# SERVICE LETTER

No. 755C

Piper Aircraft Corporation

Landing Gear Lock Actuator Rod  
and Rod End Bearing Inspection/  
Replacement.

SKETCH A

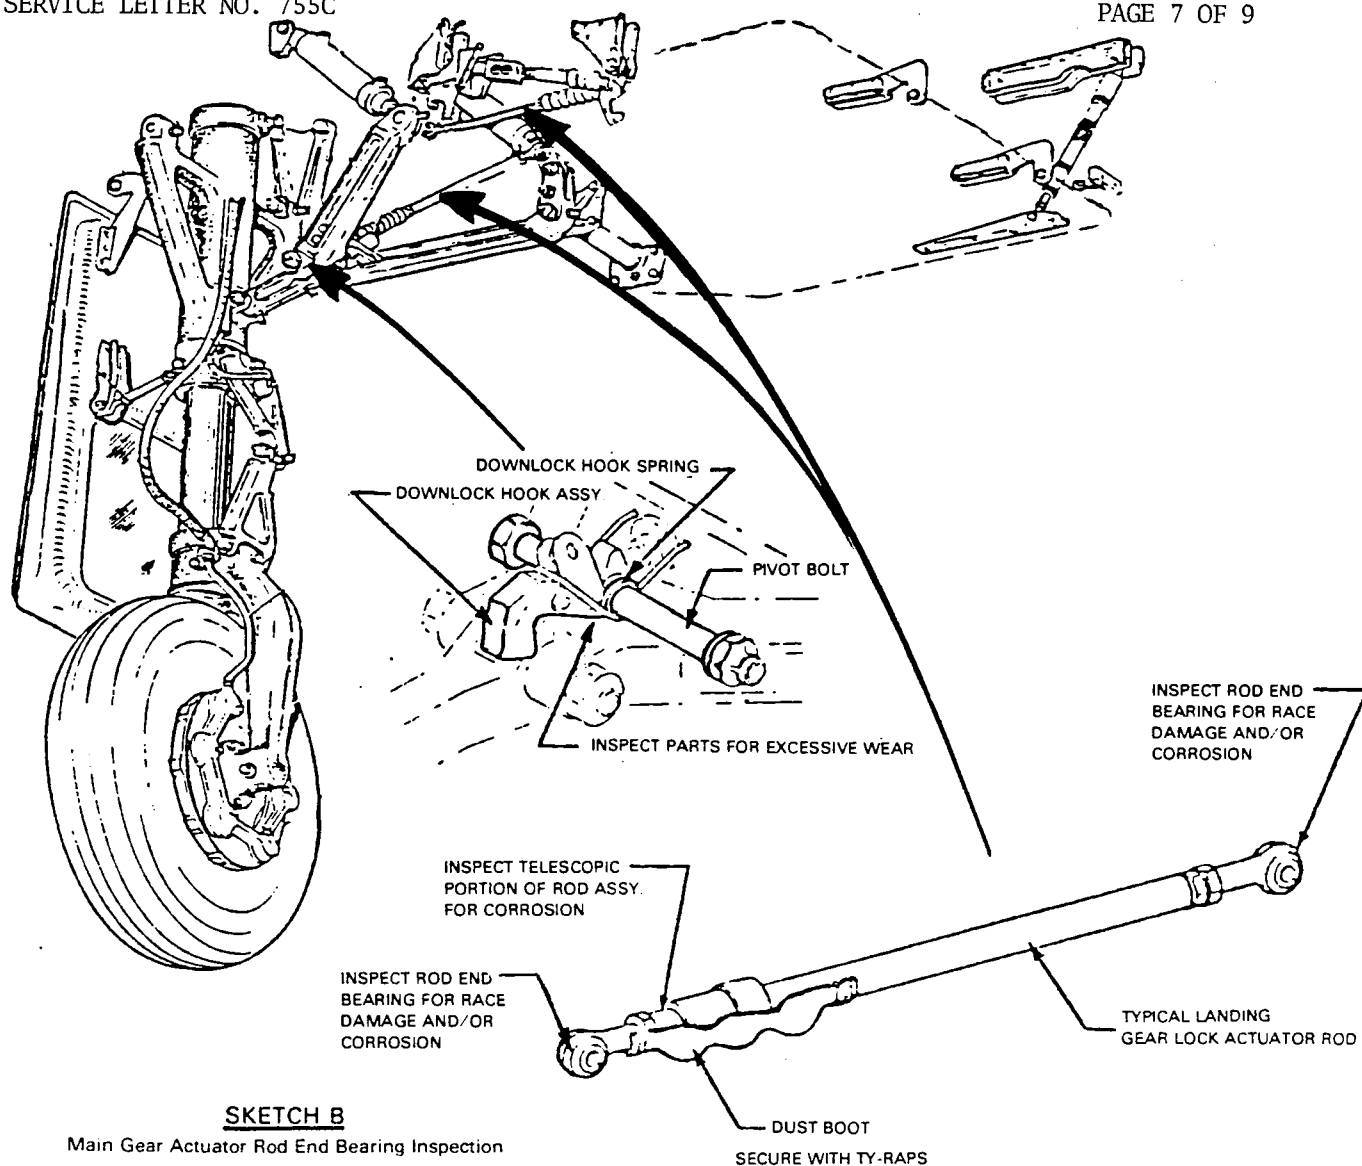
1. Locate and remove the nose gear lock actuator rod assembly from aircraft as shown.
2. Loosen the clamp attaching the dust boot to the landing gear lock actuator rod. Slide the dust boot back to expose the telescopic portion of the actuator rod assembly.

3. Inspect the telescopic portion of the landing gear lock actuator rod for evidence of corrosion.
  - a. If corrosion is evident, the landing gear lock actuator rod assembly should be replaced.

- b. If no corrosion exists, lubricate the telescopic portion with MIL-G-81322, 81827 or MIL-G-21164C lubricant.
4. Reposition and secure dust boot on each landing gear lock actuating rod assembly.

5. Inspect each rod end bearing for evidence of race damage and/or corrosion.
  - a. If corrosion is evident and/or ball and race of bearing shows evidence of damage (ball must rotate freely in race), it will be necessary to replace that bearing.

- b. If existing bearings show no evidence of corrosion or damage, lubricate bearings with MIL-L-7870 lubricant.
6. If a new main gear lock actuator rod assembly (assemblies) is being installed, lubricate the telescopic portion as described in 3b above, and the rod end bearings with MIL-L-7870 lubricant. Install existing dust boot on actuator rod assembly as shown.

7. Reinstall the nose gear actuator rod assembly on aircraft. Check system function and rigging; adjust as necessary using the appropriate Navajo Service Manual. Refer to Sketch "C" for the correct method of adjusting rod end bearings.

**SKETCH B**

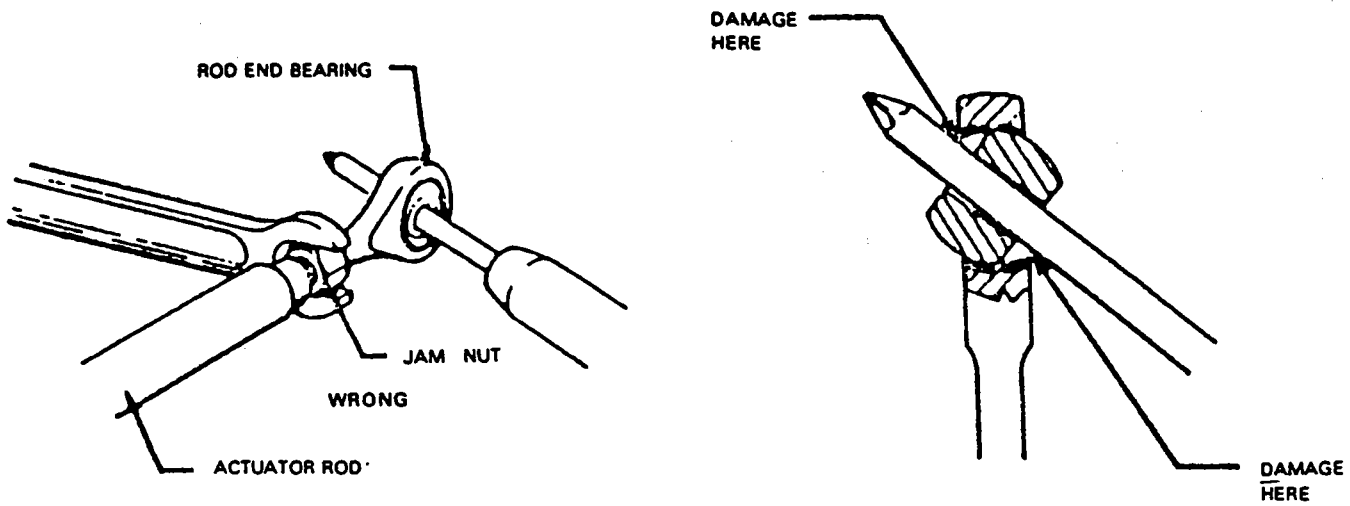
1. Locate and remove the main gear lock actuator rod assemblies from aircraft as shown. Accomplish on left and right main gear assemblies.
2. Loosen the clamp attaching the dust boot to the landing gear lock actuator rod assembly. Slide the dust boot back to expose the telescopic portion of the actuator rod assembly.

3. Inspect the telescopic portion of each landing gear lock actuator rod assembly for evidence of corrosion.
  - a. If corrosion is evident, the landing gear lock actuator rod assembly should be replaced.

- b. If no corrosion exists, lubricate the telescopic portion with MIL-G-81322, 81827 or MIL-G-21164C lubricant.
4. Reposition and secure the dust boot on each landing gear lock actuating rod assembly.

5. Inspect each rod end bearing for evidence of race damage and/or corrosion.
  - a. If corrosion is evident and/or ball and race of bearing shows evidence of damage (ball must rotate freely in race), it will be necessary to replace that bearing.

- b. If existing bearings show no evidence of corrosion or damage, lubricate bearings with MIL-L-7870 lubricant.
6. If a new main gear lock actuator rod assembly (assemblies) is being installed, lubricate the telescopic portion as described in 3b above, and the rod end bearings with MIL-L-7870 lubricant. Install existing dust boot on actuator rod assembly as shown.

7. Remove the main gear downlock hook assembly. Thoroughly clean the downlock hook assembly, downlock hook spring and pivot bolt and inspect each part for evidence of excessive wear. If any part or parts show excessive wear, those parts should be replaced.

8. Reinstall the downlock hook assembly, spring and pivot bolt on aircraft. Lubricate pivot bolt and hook with MIL-G-81322, 81827 or MIL-G-21164C Lubricant.

9. Reinstall the main gear lock actuator rod assemblies on aircraft. Check system function and rigging; adjust as necessary using the appropriate Navajo Service Manual. Refer to Sketch "C" for the correct method of adjusting rod end bearings.

CORRECT METHOD OF ADJUSTING ROD END BEARINGS

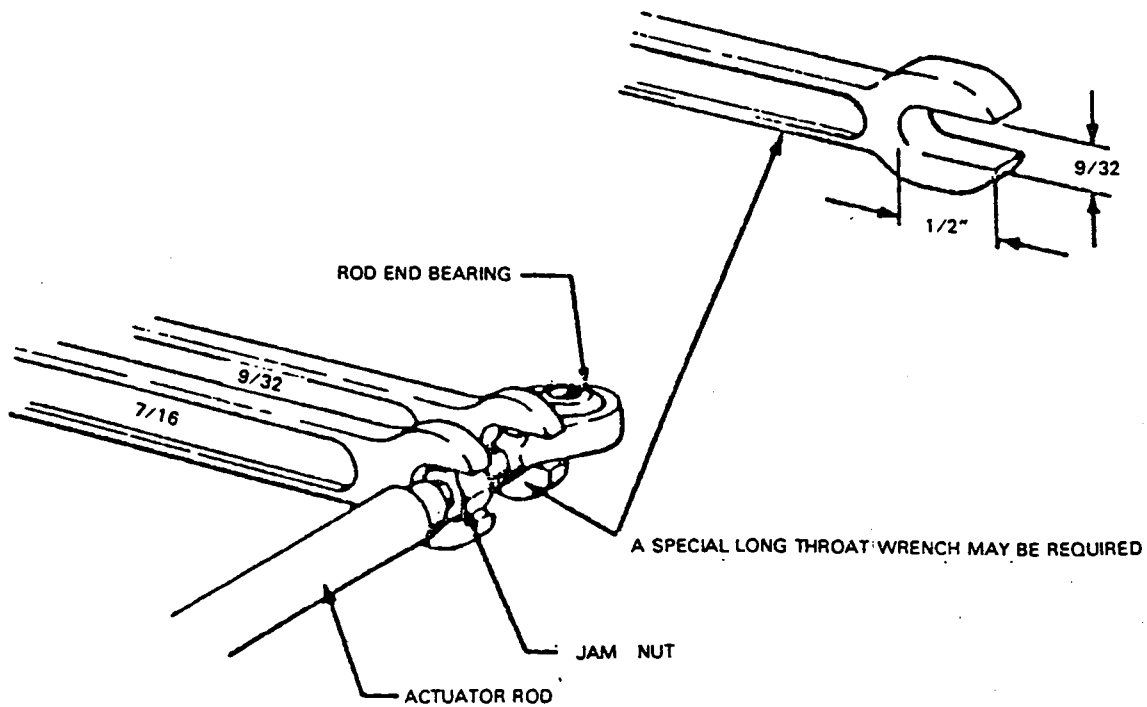
NOTE: It has been found that rod end bearings race damage - incurred during maintenance/rigging activity - has resulted in landing gear system difficulties and/or premature rod end bearing replacements. This Service Release also provides a recommended method for backholding the bearing assembly while adjusting the adjacent jam nut to prevent bearing race damage (refer to attached instruction data for details).

IMPROPER METHOD OF ADJUSTING ROD END BEARINGS  
(RESULTING IN LOCKED BALL)

SKETCH D

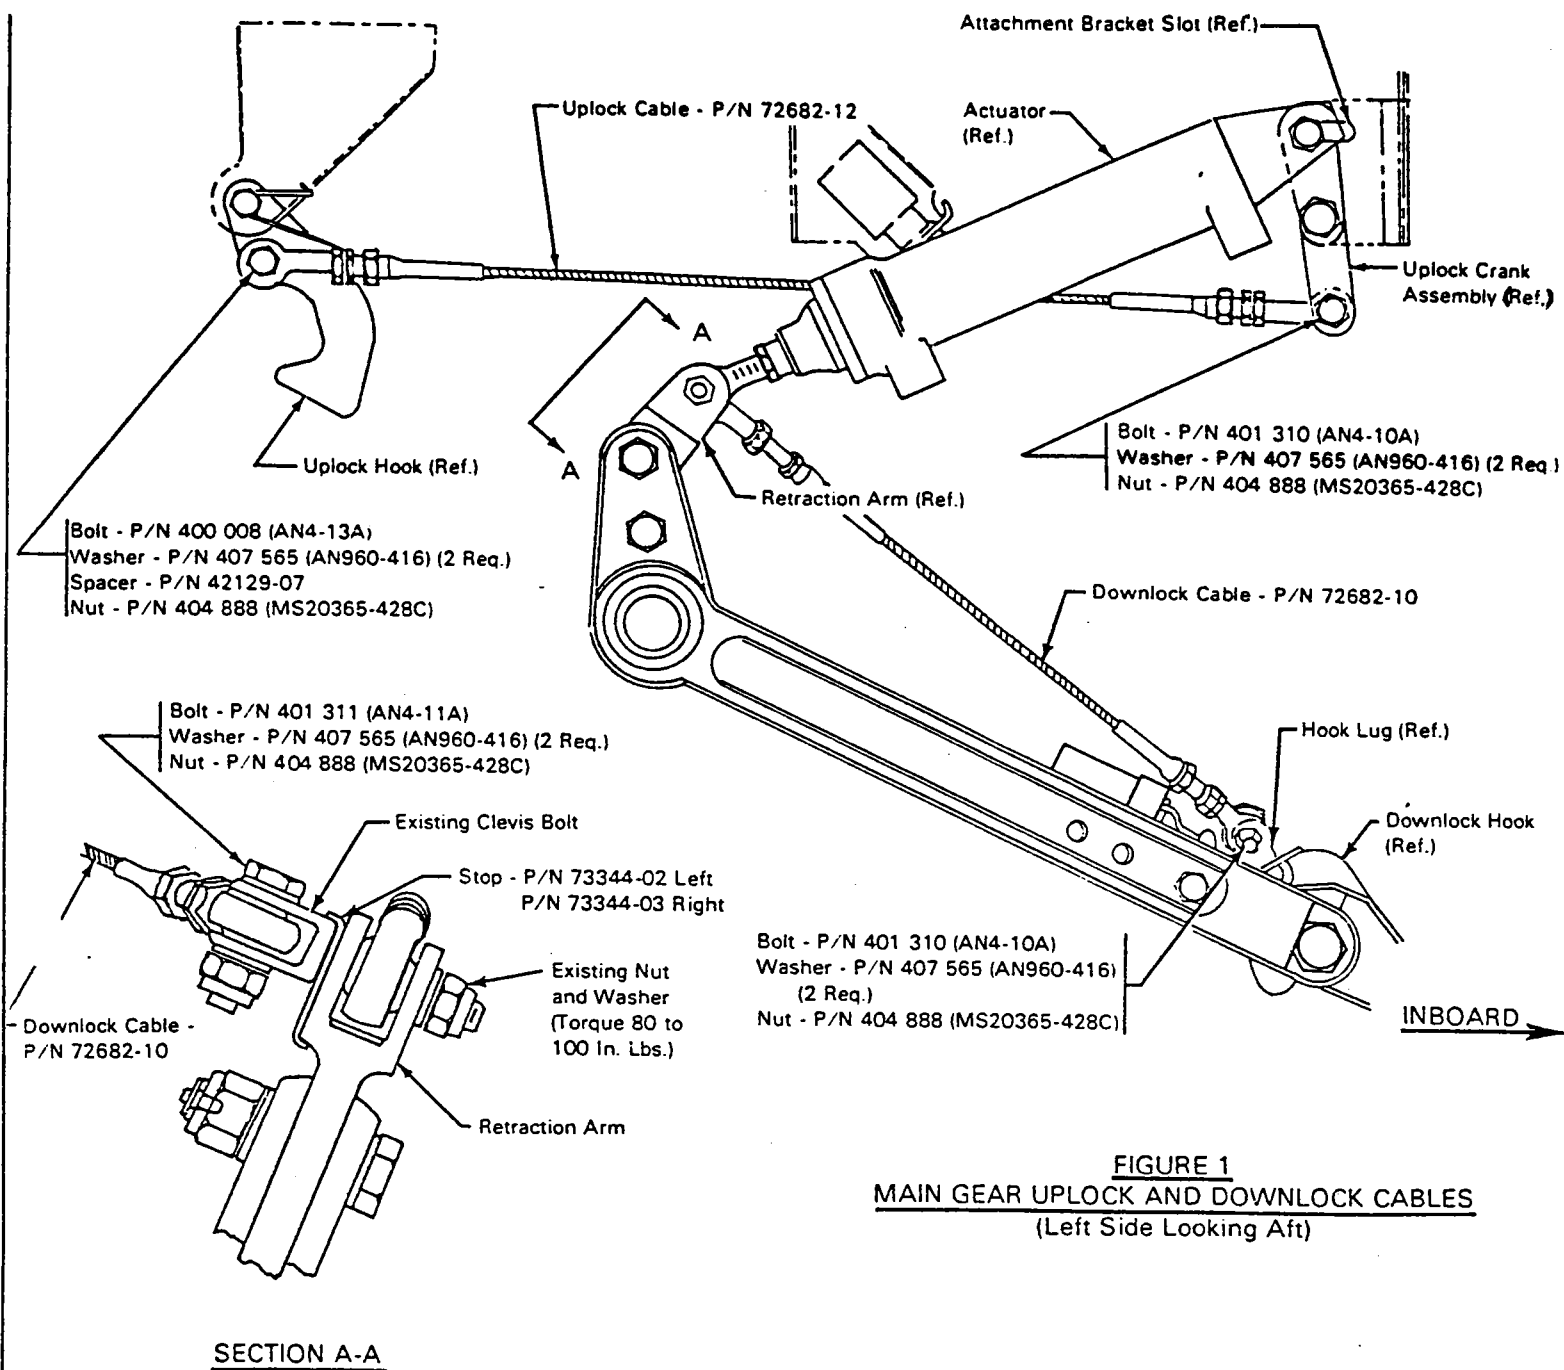
PURPOSE: Above affected models and serial numbers of aircraft were delivered with the new landing gear uplock and downlock cable assemblies. Installation of these stops between the retraction arm and clevis bolt will prevent possible rotation of the downlock cables and insure safe gear indications.

NOTE: Refer to Sketch D, Section A-A of this Service Letter for anti-rotation stop installation.

1. Remove nut and washer from the clevis bolt (fork) connecting the down-lock cable to the retraction arm.
2. Pull out the clevis bolt and install Stop, Piper Part Number 73344-02 (left side) and 73344-03 (right side) over the bolt and reinsert bolt through the retraction arm.
3. Install washer and nut and torque 80 to 100 inch pounds.
4. Repeat procedure on the opposite gear.
5. Make proper logbook entry of compliance with PART III of this Service Letter.
